Subject: MHI's Response to US-APWR DCD RAI No. 214-1920

Response to Request for Additional Information No. 214-1920,
Revision 0

US-APWR Design Certification

RAI NO.: NO. 214-1920
SRP Section: 03.09.02 – Dynamic Testing and Analysis of Systems
Structures and Components
APPLICATION SECTION: 3.9.2.2
DATE OF RAI ISSUE: 02/25/09

Figure 1(a) - Tube bundle model

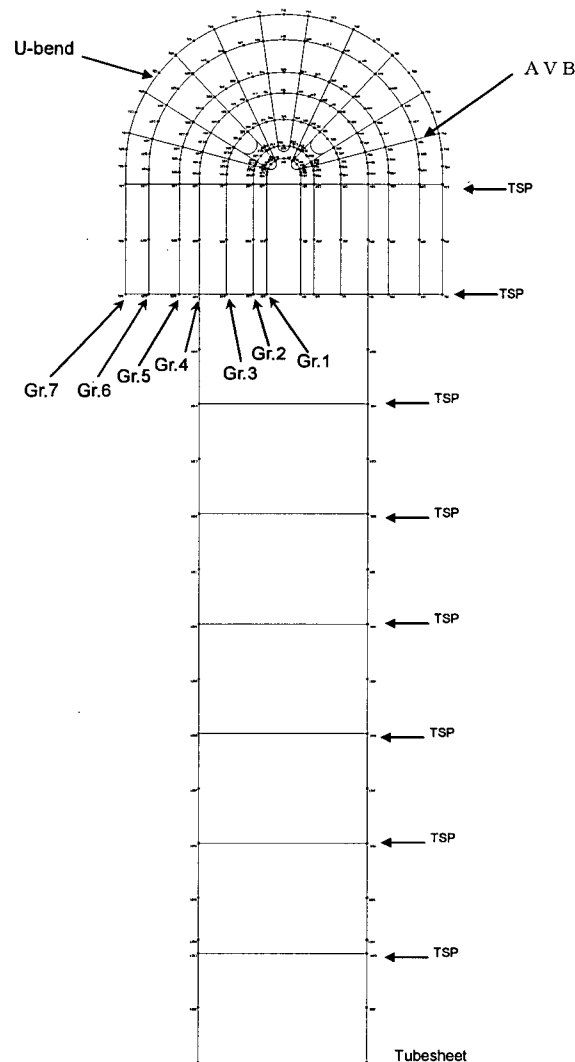
- (1) For the SG and its internals, discuss their isolated structural model in detail. This should include SG pressure boundary and its upper internals, such as feedwater headers, platforms, separators, dryers; as well as lower internals, such as tubesheet, tubes, tube support plates, anti-vibration bars, bundle wrappers, and seismic stops.
 - (2) Discuss how the hydrodynamic coupling of the SG shell to the tubes and other SG internals is simulated in the SG isolated structural model.
 - (3) Discuss how local flexibility of the SG shell at the primary nozzle connections is accounted for in the model.
 - (4) Discuss how SG component supports are modeled.
 - (5) Provide the natural frequencies and mode shapes (including their graphical representation) obtained for the SG and its internals, and, based on that, discuss the adequacy of their respective modeling.
-

The seismic model for tube bundle is shown in Figure1(a). In the model, seven tube groups of different radii represent the upper bundle. The tube elements are coupled for out-of-plane motion in the U-bend tube region and not coupled for in-plane motion, to allow the relative sliding between U-bend tube columns.
